**FINAL REVIEW
CITY OF ALLENTOWN, PENNSYLVANIA
HARB
May 9, 2019**

Item #1 - Case # HDC-2019-00009 – Proposal to construct a wood deck on second floor above concrete porch.

Property located at: 223 N 11th Street

Case # HDC-2019-00009

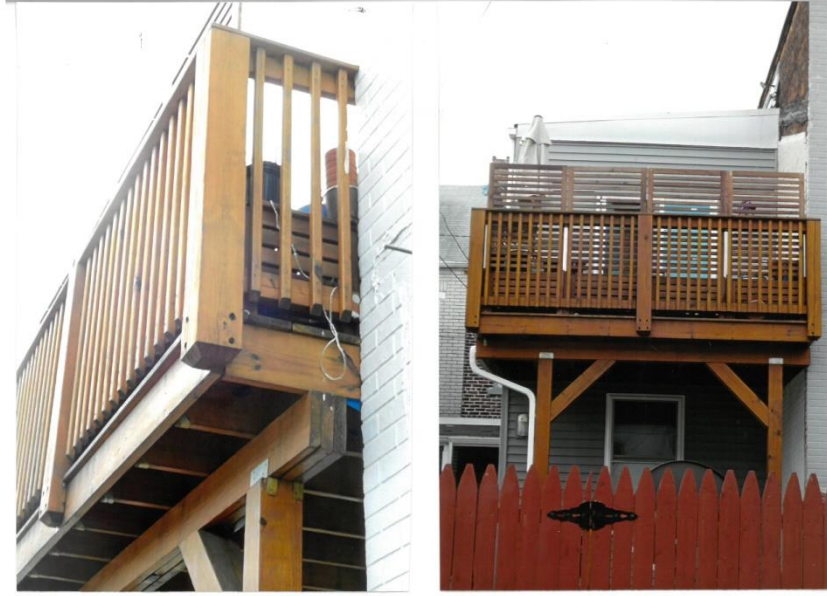
The proposed work for 223 N 11th is historically appropriate in concept with modifications recommended to make the construction less suburban in character. If possible, consideration should be given to rebuilding the brick piers as supports for the second floor porch. If that is not feasible, 6 x 6 posts were historically used and would be appropriate. A historically common corner chamfer detail might be considered for the posts. The projection of the handrail support posts beyond the face of the porch structure on the second floor is not a historically appropriate detail and consideration should be given to moving the posts to align with the posts below behind the rim joist. The size of the balusters should be increased to 1 ¼" – 1 ½" if possible and

they should be placed to the inside of the top and bottom 2 x “rails” to give the balustrade a more historic appearance. (As opposed to the detail at 221 N. 11th.) The posts, beams, joints, and balustrades should be painted or stained with an opaque stain to look like paint. Porches were historically painted. The porch decking might remain unpainted or the use of T&G composite decking (Aeratis Heritage decking are equal) be considered.

Currently there are pipe railings on the north side of the first and second porches; will these be replaced with new porch railings, and will there be a matching railing along the east side of the first level of the porch? The first floor porch level might require a railing/guard due to its height above grade.

1. The proposal to construct a wood deck on second floor above concrete porch at 223 N 11th Street was represented by Tim Driscoll.
2. The second floor porch will be supported on 6 x 6 (nom.) posts as proposed. A chamfer detail will be added to the four corners of the posts above the intersection with the handrail/guard.

3. The second floor railing posts will be reduced in size to be 4 x 4 (nom.) and moved to the inside of the rim joists.
4. The new railing system/guard will be constructed of wood and designed to match the “Key West” railing in the photo presented at the HARB meeting.

5. The balusters in the railing will be a minimum of 1 ½” square and the railing system will be 42” high on the second floor.
6. Matching railings will be installed on the first floor of the porch including the existing inset porch areas, except that the height of the railing on the first floor will be determined by prevailing building code.

7. The porch decking material will be 1x4 (nom.) tongue and groove fir or Ipe. A composite 1 x 4 (nom.) tongue and groove “Heritage” porch decking by Aeratis (or equal) was also approved as an alternate to wood.

8. The posts, railings and structure will be finished with a solid, opaque colored stain to look like paint in a color that blends with the building colors.

9. A black steel, traditionally shaped, handrail will be installed on one or two sides of the steps to the concrete porch.
